ADA Curb Ramp New Construction Inspection Form (Perpendicular)

Nw 288 ter

24952.54

Nw carver st

PERPENDICULAR RAMP (PR)

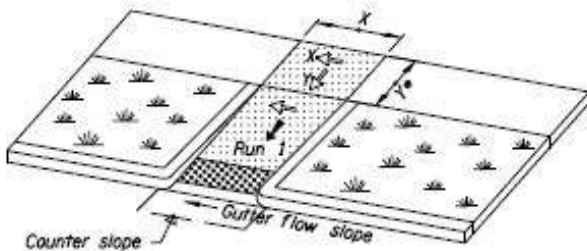
Cross Slope 1

2.8

IITD tool joints in turn space
